CITY OF ALBUQUERQUE

PLANNING DEPARTMENT – Development Review Services

RE: Cuatro Development – 1319 4th St. NW (File: J14D173)
Grading & Drainage Plan, Engineer's Stamp Date 11-17-2014
Engineer's Certification Date 6-23-16

FILE:	DRAINAGE AND GRADING PLAN CUATRO DEVELOPMENT-NORTH HALF	DATE/REVISIONS:
		SHEET NUMBER: CIVIL104 2 OF 4
APPLIED ENGINEERING AND SURVEYING, INC. ENGINEERS AND PLANNERS 1000 West Drive NE Albuquerque, New Mexico 87112 Office: (505) 485-8728 gordon@aesn.com

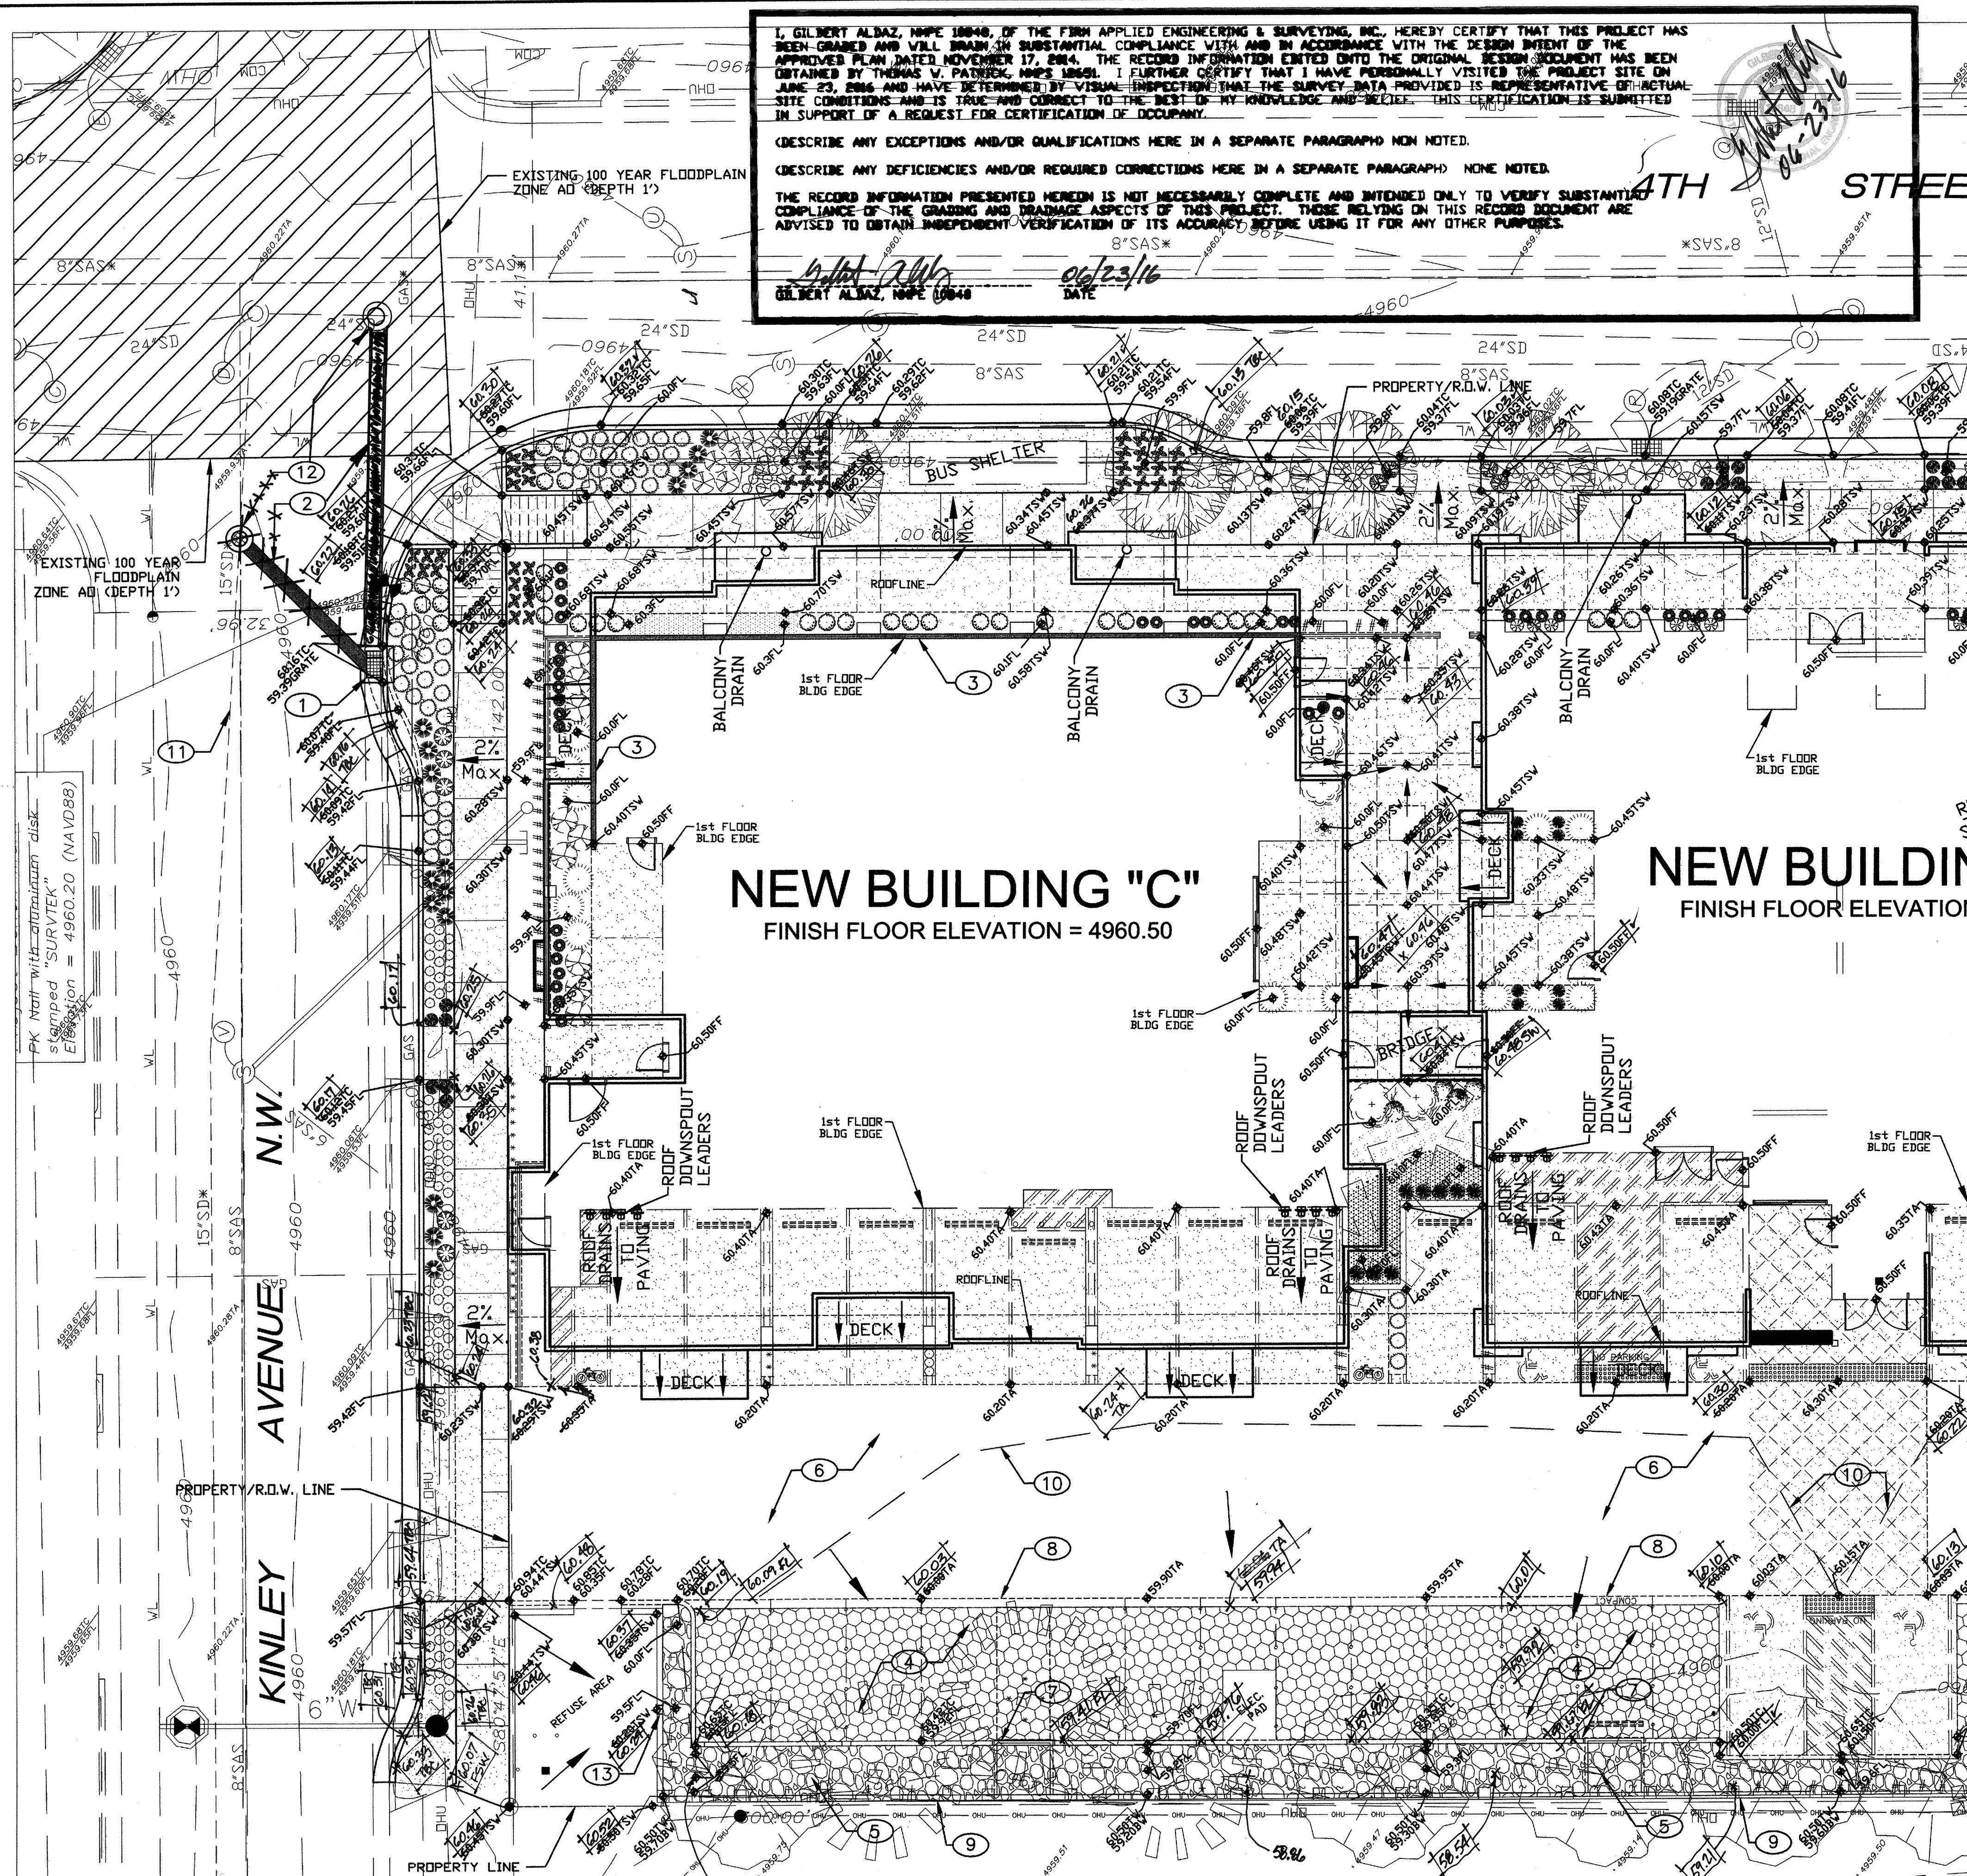
- Balconies cannot discharge into the sidewalk nor can any portion of the roof sheet flow and discharge into sidewalk below (including private sidewalk). It is recommended that for balconies that presently discharge into sidewalk below, the drain be relocated to drain into the adjacent roof. The roof will then require a gutter and down-spout system to discharge to the nearest landscaping. Please coordinate with the architect.

- Area with Geogrid system is to drain into channel along western boundary. The curb cuts are not deep enough, and the channel is filled with cobble. Per the Grading and drainage plan, the cobble should be approximately 8" – 12" below the top of curb. To rectify the problem, the following fixes are recommended:

- In parking area, the infill material of the Geogrid system is extremely unstable and must be stabilized. Per the specs, a well – graded material was recommended (see snapshot below). Mixing in crusher fines, angular rock, and smaller diameter rock to improve gradation is recommended.

- Core drill holes in the curb, just above the Geogrid
 - Between the landscaping bushes in the channel, lower the top of rip-rap /cobble to about 14"-18" below the top of curb. The increase in depth is to compensate for the volume taken up by the landscaping bushes. Water should be able to flow from low spot to low spot between the bushes.
